SVE BULLETIN

QVM Bulletin: Q-240R2

Guidance for Installing Aftermarket Transit Van Partitions / Bulkheads

Models Affected: Transit Vans, 2016 Model Year through 2021 Model Year.

Figure 1: Airbag Keep-out zones (Medium and High roof)

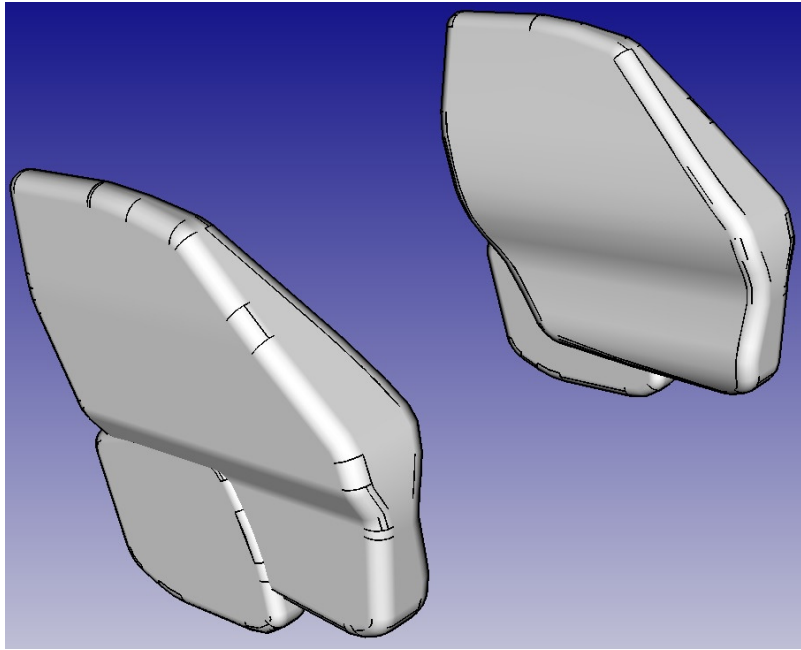
Partitions or Bulkheads installed in Transit Vans must not interfere with airbag deployment zones. CAD of the Medium and High roof Airbag keep-out Zones is available upon request. Partition / Bulkhead should be positioned rearward of the prescribed keep-out zone.

Additionally, The RH / LH foam blocks cannot be removed or modified. To prevent damage to the deploying airbag, panel closeout around foam blocks should be a soft edge and the forward attaching face of the partition / bulkhead should have no exposed protruding fasteners or sharp edges.

Figure 2

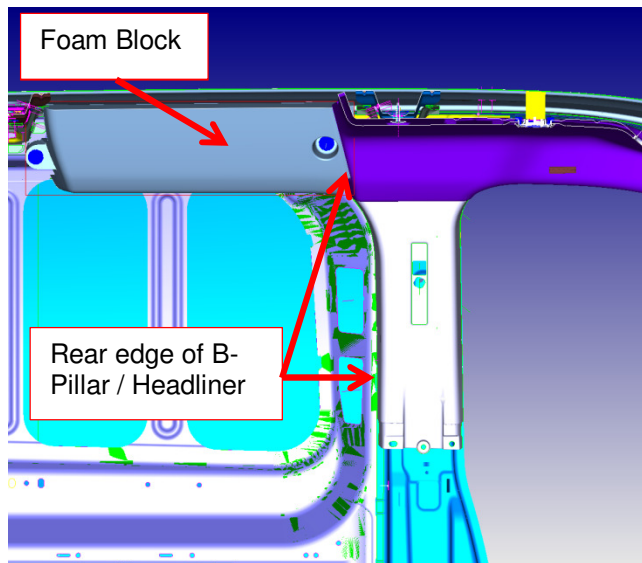
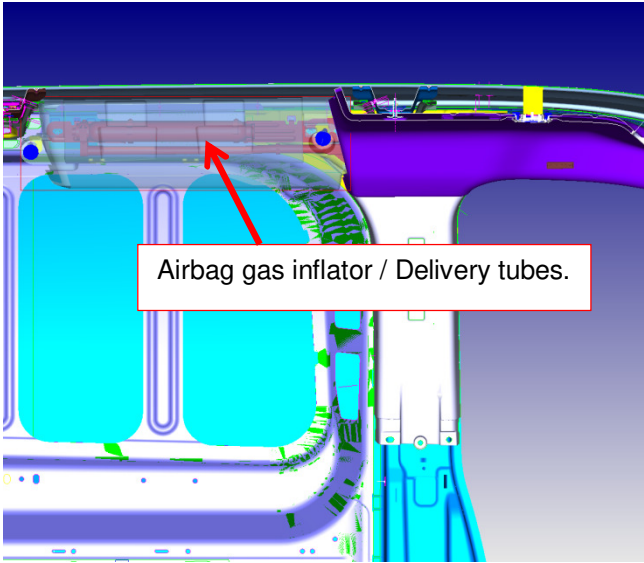
Partitions and Bulkheads need to be positioned at or rearward of the front headliner / B-pillar trim surface while maintaining existing headliner and B-pillar surface. Bulkhead cannot attach directly to the headliner to ensure proper airbag deployment. (See figures 2 and 3)

Additionally, The RH / LH foam blocks cannot be removed or modified. To prevent damage to the deploying airbag, panel closeout around foam blocks should be a soft edge and the forward attaching face of the partition / bulkhead should have no exposed protruding fasteners or sharp edges.

Figure 4: Seat Belt retractor location (Left side Shown)

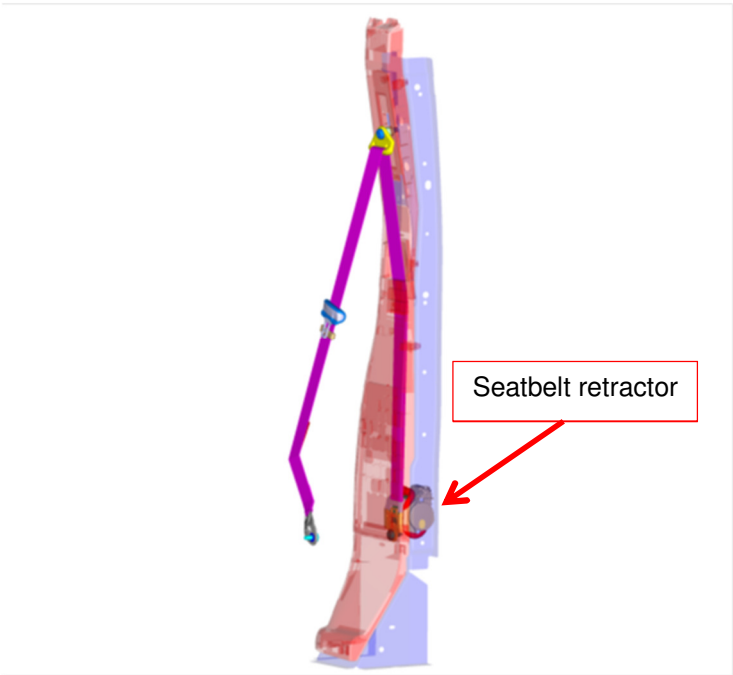
partition), the modifier must ensure that drilling operations and/or fasteners do not damage the seatbelt retractor. Damage to the seat belt retractor caused by a vehicle modifier is not a warrantable charge.

When fastening any aftermarket equipment to the B-pillar (such as a bulkhead
